Chemical Name: Metalaxyl

Company Name: Ciba-Geigy Corporation

REVIEW OF PROTOCOL FOR SMALL-SCALE RETROSPECTIVE GROUND-WATER MONITORING STUDY

Title: 1) Small Scale Retrospective Study for Metalaxyl in Ground-Water: A Protocol.
2) Metalaxyl in Ground Water: A Ground-Water Sensitivity Analysis for Ridomil Application.

TITLE		
15 ACRE		
EXPERIMENTAL FIELD		
PREPARED FOR		
CIBA-GEIGY CORPORATION		
ROUX Consulting Ground-water Geologists ROUX ASSOCIATES INC	SCALE	FIGURE
	DATE	II
	2" = 250'	
	3/89

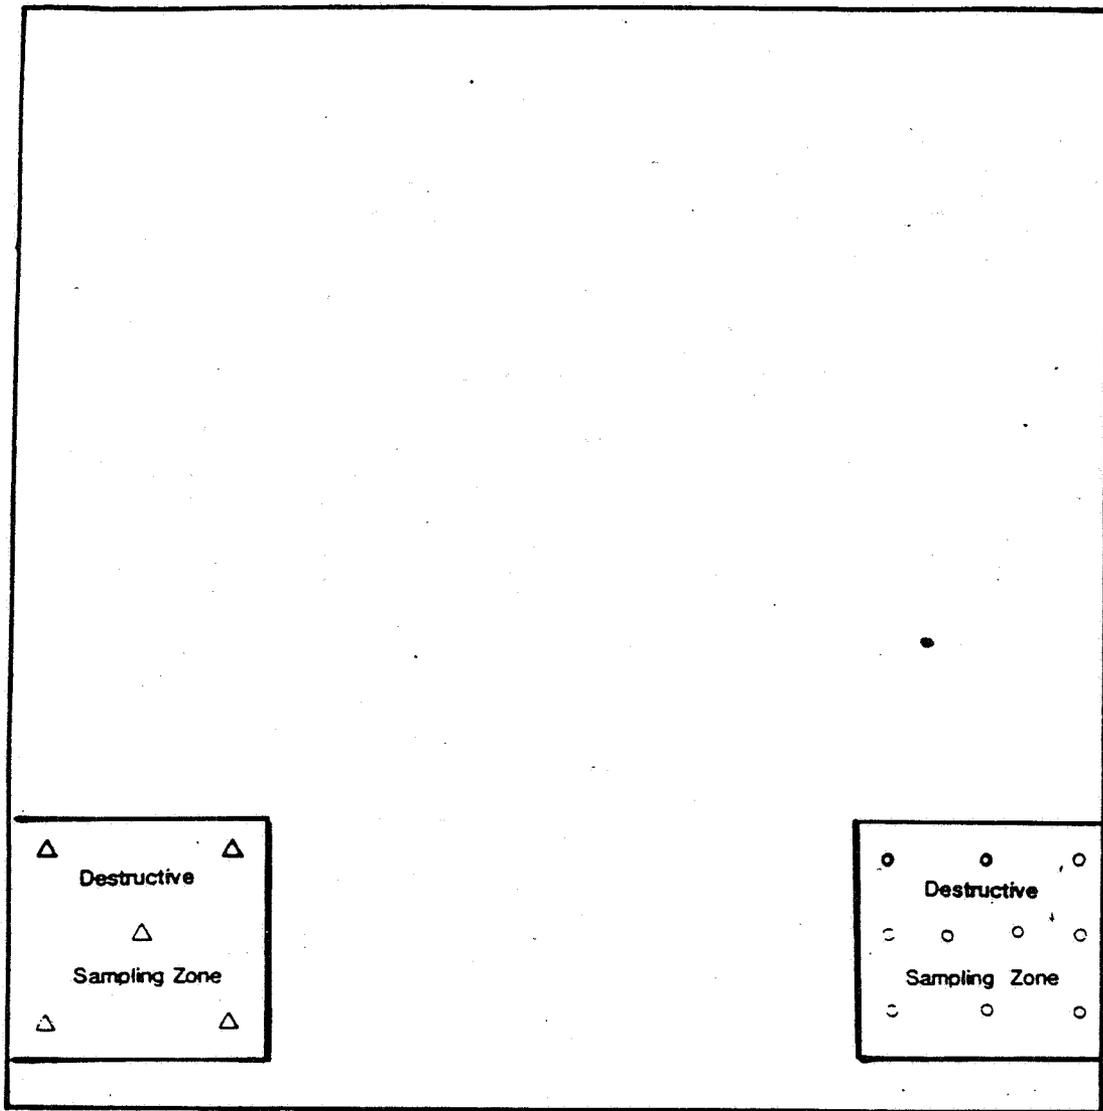
The proposed site design assumes a 15 acre site will be found, and dedicates 2 subplots (approximately 2 acres each) for destructive sampling such as soil cores, suction lysimeters, and dye tests (see Figure II attached). These subplots are to be located upgradient of 2 of the 3 proposed observation well clusters. The tacit assumption in this approach is that soils are uniform both horizontally and vertically at the 15 acre site, and that sampling an area that is 13 percent of the total area is representative of the site. It should be clearly shown that this is the case (for example, by doing a soil survey).

Suction Lysimeters. Ten suction lysimeters are to be located in a subplot similar to that used for soil cores. Lysimeters sample from only a limited area (approximately 1 meter), and therefore, results will be extrapolated from this small study area to the rest of the field. A discussion of the vertical variability of media in the unsaturated zone at the site should be included in the report to justify this.

The protocol states (p. 10) that "Each lysimeter will be set at six feet below the land surface." An alternative is to place clusters of lysimeters at different levels (e.g. 3, 6, and 9 ft.) in order to better define the vertical movement of pesticides in the unsaturated zone. This scenario is recommended in the guidelines for a small-scale prospective study in the Draft Guidance document referred to above.

Observation Wells. The proposed design for monitoring well locations indicates that the downgradient wells will "if possible, be installed outside of the area of pesticide application" (p. 12). The Ground-Water Section maintains that if the wells are properly constructed, there is little chance of direct contamination from spraying. Of more concern is the possibility, depending on the hydraulic properties of soils, and the ground-water gradient at the site, that the monitoring period may be insufficient to allow ground water to migrate from the treated field to the monitoring well. The registrant should measure the direction of flow and ground-water velocity, and calculate pesticide travel time to prove that off-site wells will indeed intercept ground water from the treated field.

5) Prior to the installation of downgradient monitoring wells off site, the registrant should show by measurements and calculations of ground-water velocity, direction, and pesticide travel time (from the edge of field to the location of the proposed well) that ground water from the site will be intercepted by the monitoring wells within the timeframe of the monitoring study.
